## Certificate of Appropriateness

**Property** 1921 N. 2ND ST. Brewers Hill HD

**Description of work** Construct new two car garage at alley, at over 100' from the front lot line per the attached

**Date issued** 5/17/2018 PTS ID 114483 COA: new garage

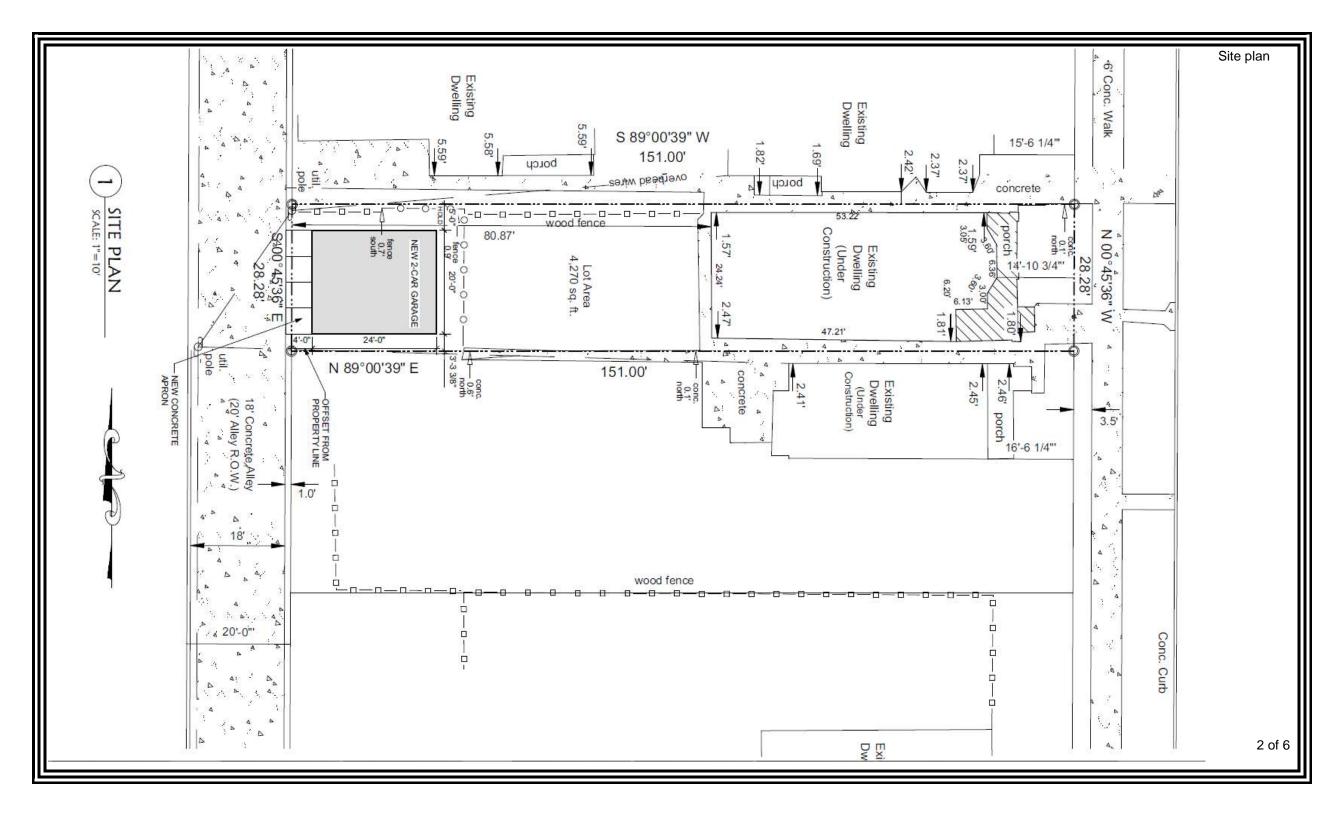
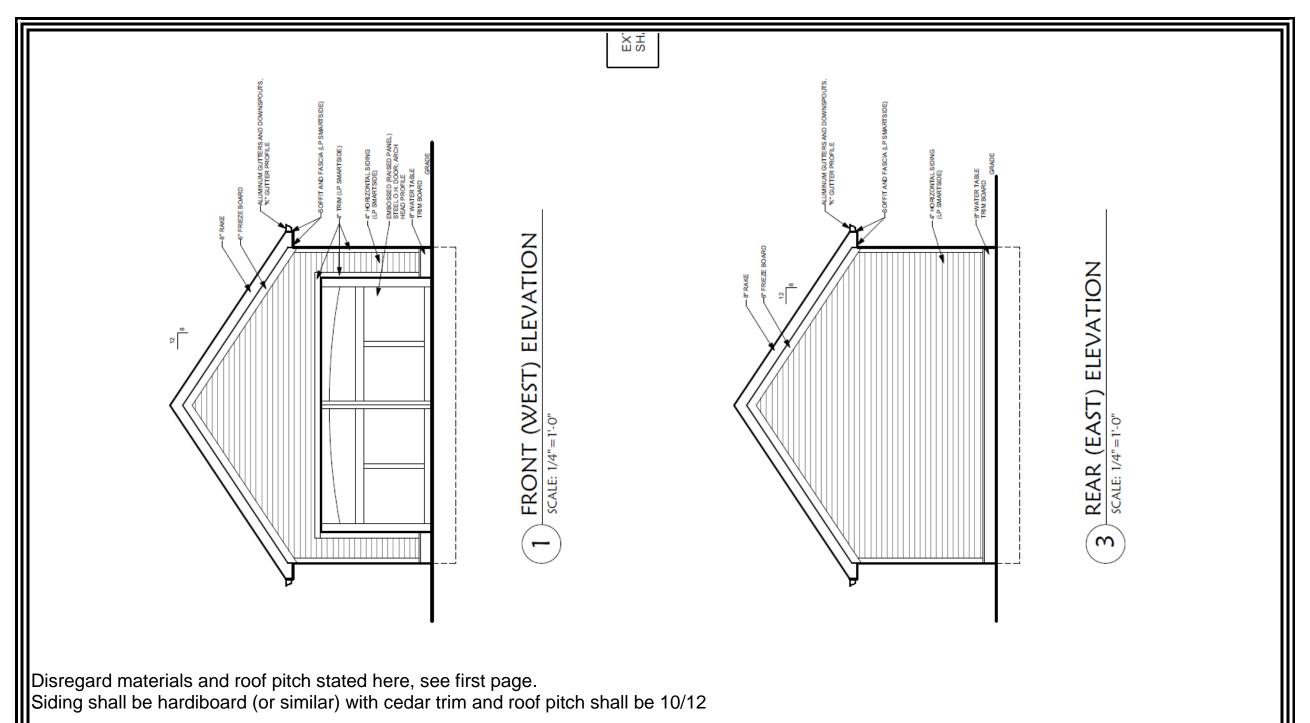
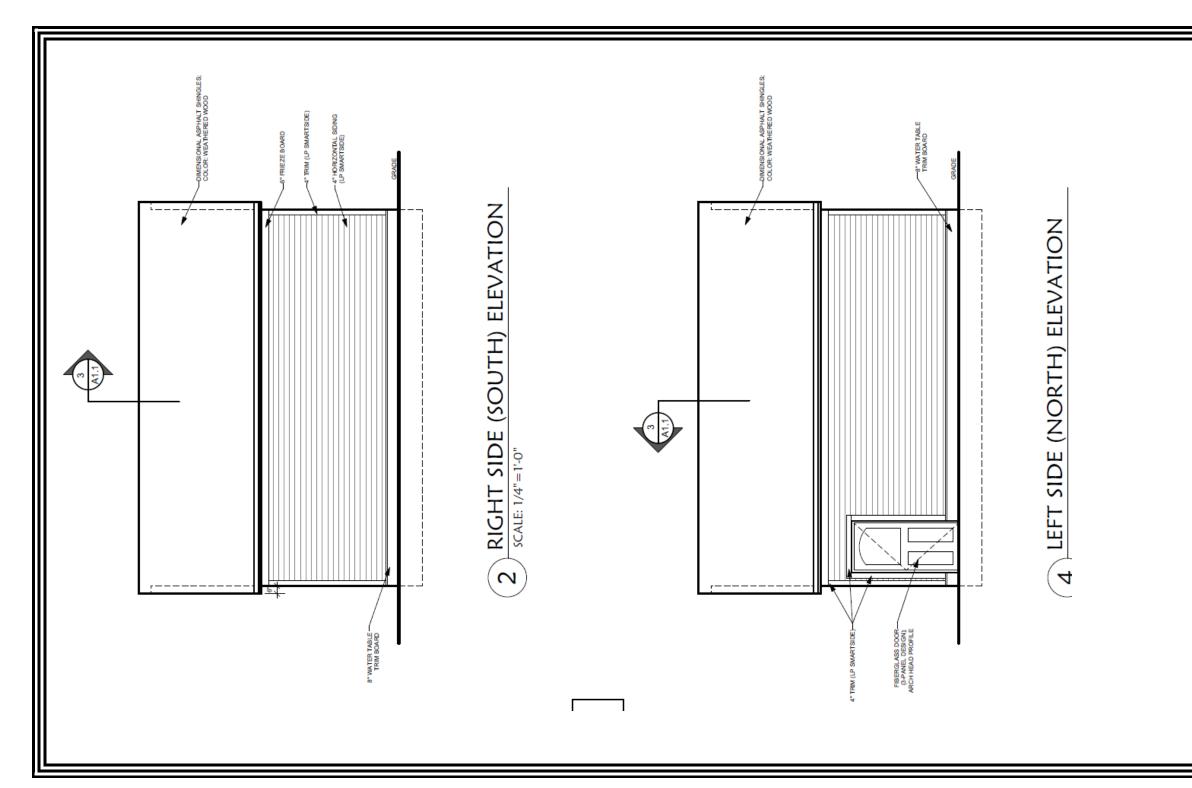
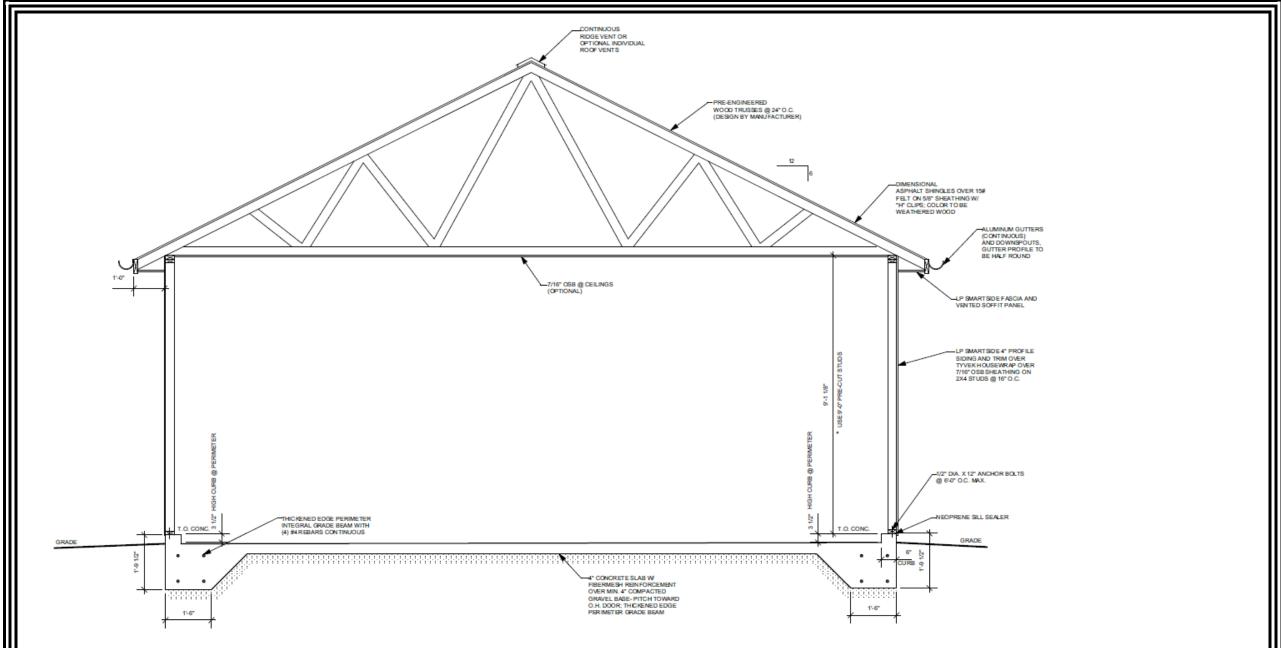
Disregard materials and roof pitch stated here, see first page.
Siding shall be hardiboard (or similar) with cedar trim and roof pitch shall be 10/12

drawings with the following alterations to that which is stated on the drawings. Garage is to be constructed with cementitious fiber plank siding with <u>smooth</u> finish (Hardieboard or similar). Trim shall be clear grain cedar wood or similar rot-resistant species. Pitch on roof shall be

increased to 10/12.

1. Ttrim to be rot-resistant, clear-grain wood.
